## #335 CABLE TRAY OVER HARD LID CEILING

RE: AWSOM – ROM – Change Cable Tray to Conduit Over Hard Lid Areas

03/10/2023  
**AWSOM**  
 Bentonville, AR

① TECHNOLOGY - LEVEL 1 RCP - AREA B  
 1/8" = 1'-0"

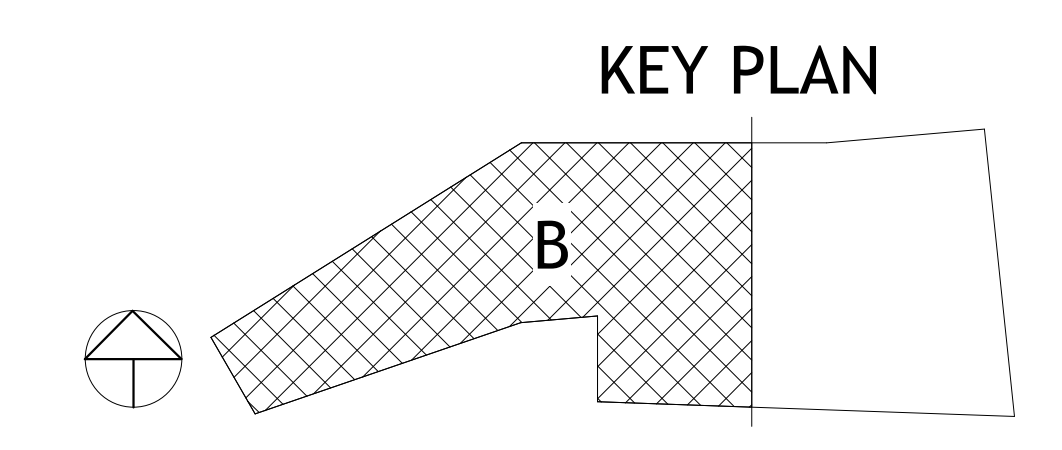
The highlighted areas in the attached drawings are where there is open air cable tray above a hard lid ceiling. We are recognizing that these areas will be inaccessible without multiple access panels. There are already 2 access panels in this ceiling to access HVAC equipment. There is the opportunity to change from cable tray to (4) 4" EMT conduits at these locations, however, there is a cost impact (ROM attached). Please consider this alternative and advise Crossland if this would be desired by design team and Ownership.

- Delete approximately 100' of cable tray and associated hardware.
Install (4) 4" raceways over hard lid areas that previously showed cable tray.

Anne Worley (Polk Stanley Wilcox Architects): Alternative is acceptable.

COMMENTS
<b>OVERVIEW</b>	<p>The highlighted areas in the attached drawings are where there is open air cable tray above a hard lid ceiling. We are recognizing that these areas will be inaccessible without multiple access panels. There are already 2 access panels in this ceiling to access HVAC equipment. There is the opportunity to change from cable tray to (4) 4" EMT conduits at these locations, however, there is a cost impact (ROM attached). Please consider this alternative and advise Crossland if this would be desired by design team and Ownership.</p>
<b>RESPONSE</b>	<p>Alternative is acceptable. Proceed with the proposed solution.</p>

① TECHNOLOGY - LEVEL 1 RCP - AREA B  
 1/8" = 1'-0"

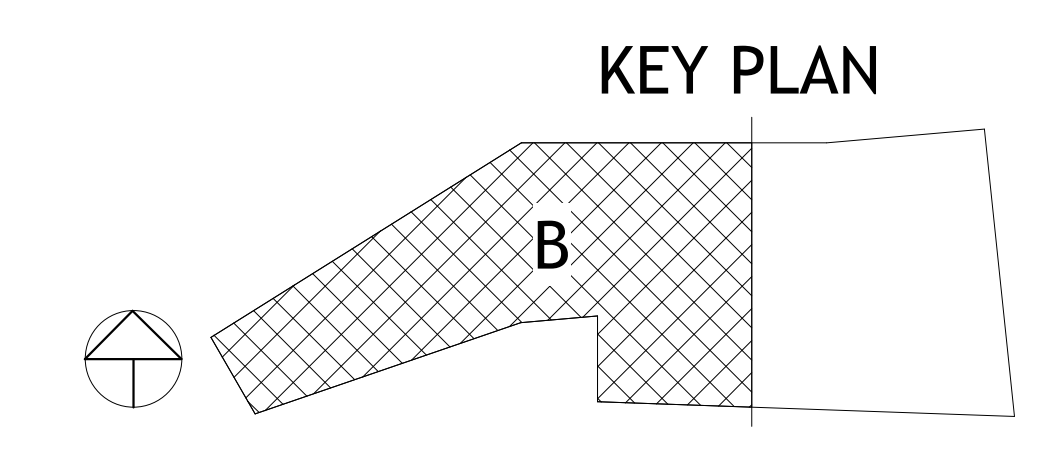
The highlighted areas in the attached drawings are where there is open air cable tray above a hard lid ceiling. We are recognizing that these areas will be inaccessible without multiple access panels. There are already 2 access panels in this ceiling to access HVAC equipment. There is the opportunity to change from cable tray to (4) 4" EMT conduits at these locations, however, there is a cost impact (ROM attached). Please consider this alternative and advise Crossland if this would be desired by design team and Ownership.

- Delete approximately 100' of cable tray and associated hardware.
Install (4) 4" raceways over hard lid areas that previously showed cable tray.
